PROJECT NOTES
REGARDING TSMP IMPROVEMENTS

TYPE	YEAR	PROJECT NO.	SHEET NO.
PS&E	2026	CPR-53(66)	15

SIGNAL
LAYOUT

SR-56 (S. GRUNDY QUARLES HWY.) SCHOOL SPEED ZONE AT GAINESBORO ELEMENTARY SCHOOL, SOUTHBOUND DIRECTION

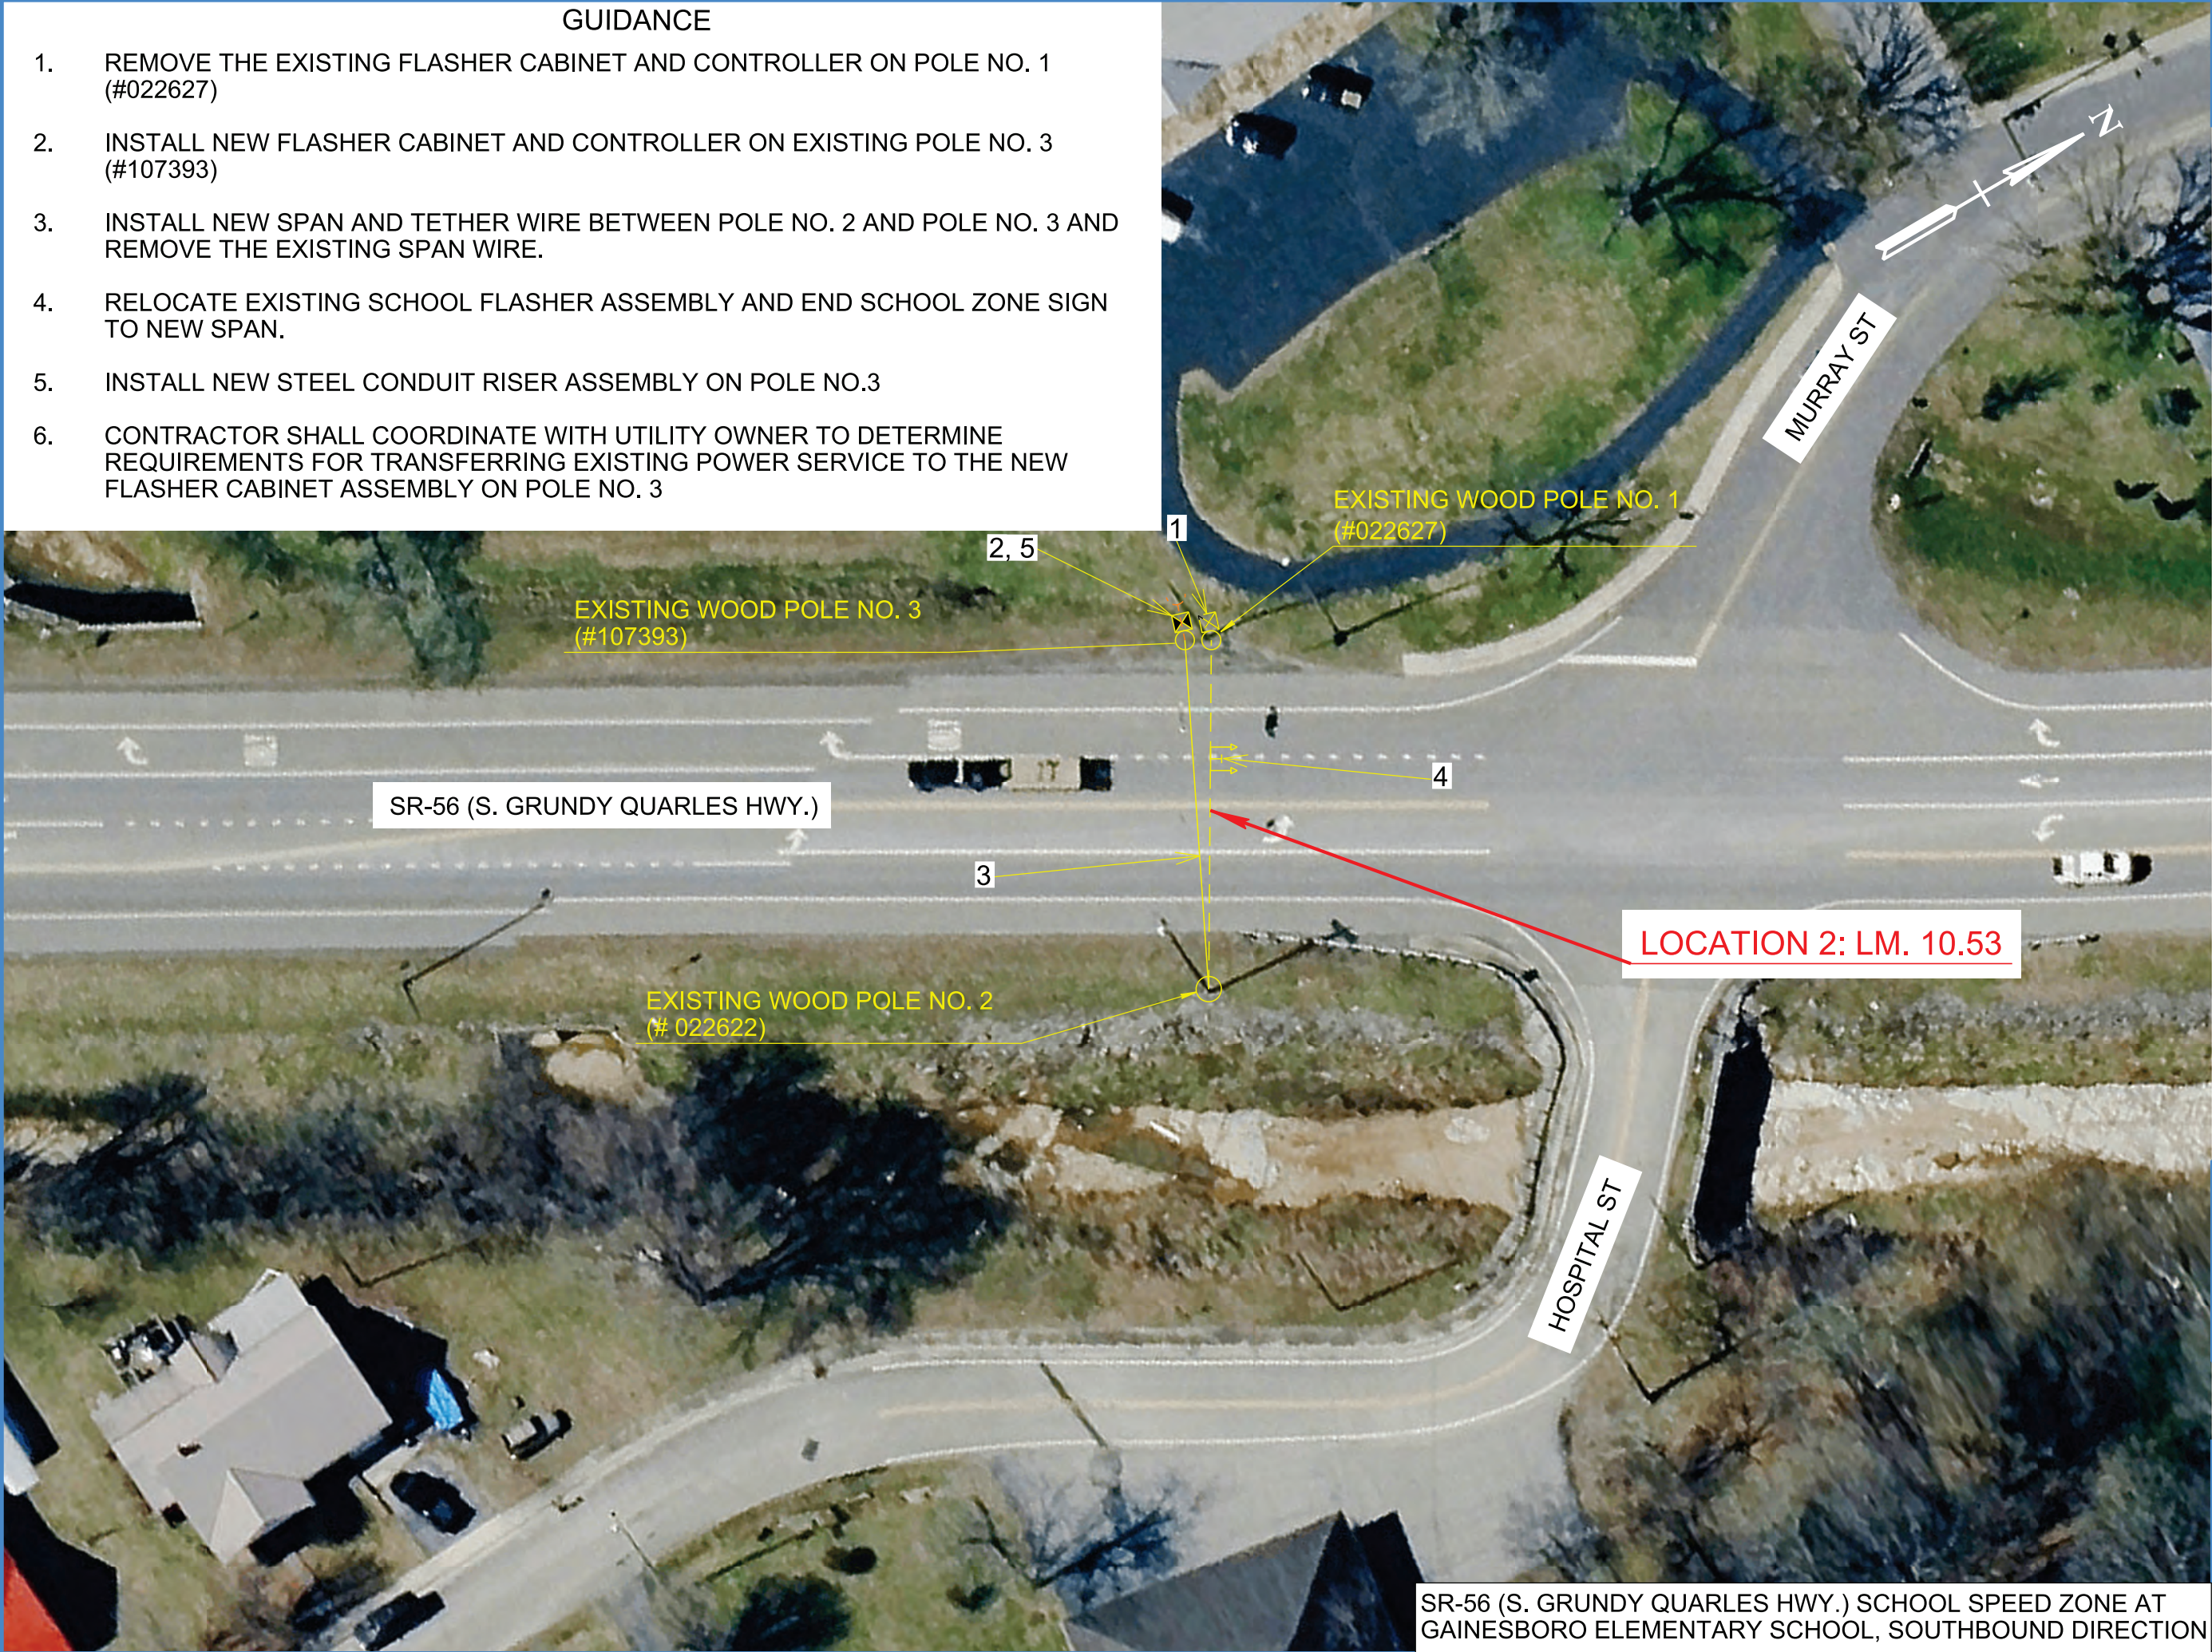
- 1. REMOVE THE EXISTING FLASHER CABINET AND CONTROLLER ON POLE NO. 1 (#022627)
- 2. INSTALL NEW FLASHER CABINET AND CONTROLLER ON EXISTING POLE NO. 3 (#107393)
- 3. INSTALL NEW SPAN AND TETHER WIRE BETWEEN POLE NO. 2 AND POLE NO. 3 AND REMOVE THE EXISTING SPAN WIRE.
- 4. RELOCATE EXISTING SCHOOL FLASHER ASSEMBLY AND END SCHOOL ZONE SIGN TO NEW SPAN.
- 5. INSTALL NEW STEEL CONDUIT RISER ASSEMBLY ON POLE NO.3
- 6. CONTRACTOR SHALL COORDINATE WITH UTILITY OWNER TO DETERMINE REQUIREMENTS FOR TRANSFERRING EXISTING POWER SERVICE TO THE NEW FLASHER CABINET ASSEMBLY ON POLE NO. 3

REVISED 09/21/2026: REVISED GUIDANCE NOTES. ADDED EXISTING WOOD POLE # 3, NEW SPAN WIRE AND POLE NUMBERS.
